PARTS & SERVICE NEWS

REF NO. | AA99168

SUBJECT: BATTERY TO RELAY AND RELAY TO FUSE CABLE LENGTH

APPLICATION: WA320-3L Wheel Loader Serial Number A30001 thru A30405 WA380-3L Wheel Loader Serial Number A50001 thru A50397 WA420-3L Wheel Loader Serial Number A30001 thru A30139 WA450-3L Wheel Loader Serial Number A30001 thru A30361

PARTS LIST

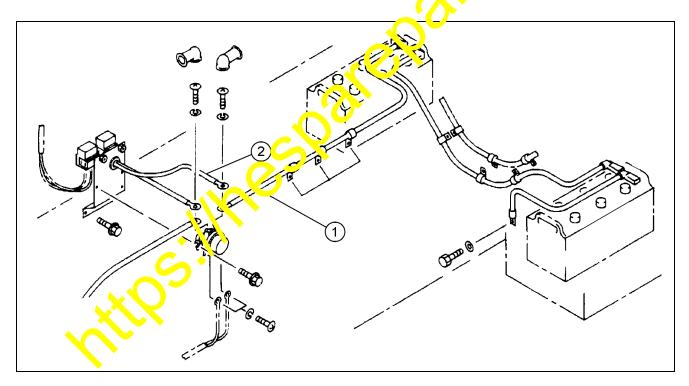
DESCRIPTION: Currently installed cables are too short. These will be r placed with longer cables.

Item	Status	Part Number	Descriptic	Qty.	Remarks
2	Old	419-06-A1290	Cable, Relay to Fuse	1	WA320-3L
	New	423-06-A1170	Cable, Relay to Puse	1	
1	Old	424-06-12840	Cable, Battery to Relay	1	WA380-3L
	New	423-06-A1180	Calle, Pattery to Relay	1	
2	Old	419-06-A1290	Cable, Relay to Fuse	1	
	New	423-06-11170	Cable, Relay to Fuse	1	
1	Old	424 50-12840	Cable, Battery to Relay	1	WA420-3L
	New	123 06-A1180	Cable, Battery to Relay	1	
2	Ola	+19-06-A1290	Cable, Relay to Fuse	1	
	Jew	423-06-A1170	Cable, Relay to Fuse	1	
2	Old	419-06-A1290	Cable, Relay to Fuse	1	WA450-3L
	New	423-06-A1170	Cable, Relay to Fuse	1

- 1. Remove the negative cable from the battery.
- 2. Referring to the parts list, remove the appropriate cable(s) for the machine being serviced, then install the new cable(s).
- 3. Reconnect negative battery cable and return machine to service.
